Access Compliance Report

Public Rights-of-Way

(Curb Ramps)

Intersection ID: 23568	Main Street: CASTLEGATE_DR	Cross Street: RUGBY_LN	Location: NE
ADA ID: 46E271BEE06B	Ramp Type: PerpDiag	Initial Pass/Fail: Fail	Overall Compliance: No
Severity Score: 58.75			
Codes/Mitigation Info/Possible Solution		Field Measurements/Component Compliance

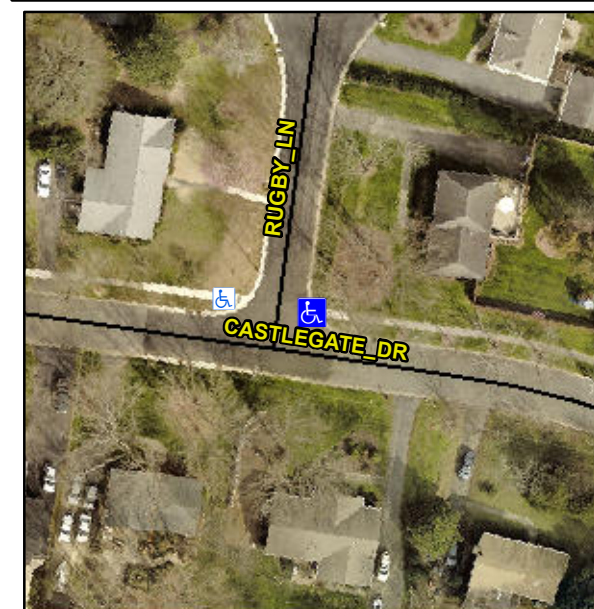
Not Found, R304.5.1, R304.2.2, R304.5.3

Compliance	Description	Data	Compliance	Description	Data
N/A	Ramp Length (in)	30.0	No	Ramp Slope (%)	12.6
No	Ramp Width (in)	46.5	No	Ramp XSlope (%)	7.6
N/A	Flare Type LT	N/A	N/A	Flare Type RT	N/A
N/A	Flare Slope LT (%)	N/A	N/A	Flare Slope RT (%)	N/A
N/A	Flare Traversable LT?	N/A	N/A	Flare Traversable RT?	N/A
N/A	Landing Length (in)	N/A	N/A	DWS Provided?	N/A
N/A	Landing Width (in)	N/A	N/A	DWS Contrast?	N/A
N/A	Landing Slope (%)	N/A	N/A	DWS Length (in)	N/A
N/A	Landing X Slope (%)	N/A	N/A	DWS Full Width?	N/A
N/A	Landing Curb? (Y/N)	N/A	N/A	DWS Offset (in)	N/A
N/A	Shared Landing?	N/A			
N/A	Gutter Ponding?	N/A	N/A	Gutter Slope (%)	N/A
N/A	Gutter Lip Ht (in)	N/A	N/A	Gutter X Slope (%)	N/A
N/A	Painted X Walk1?	No	N/A	Painted X Walk2?	No
	X Walk 1 Direction	To NW		X Walk 2 Direction	To SW
N/A	X Walk 1 Width (in)	N/A	N/A	X Walk 2 Width (in)	N/A
	X Walk 1 Slope (%)	1.2		X Walk 2 Slope (%)	3.0
	X Walk 1 X Slope (%)	2.1		X Walk 2 X Slope (%)	3.3

Remove & Replace Curb Ramp With Two New Directional Ramps or Equivalent.
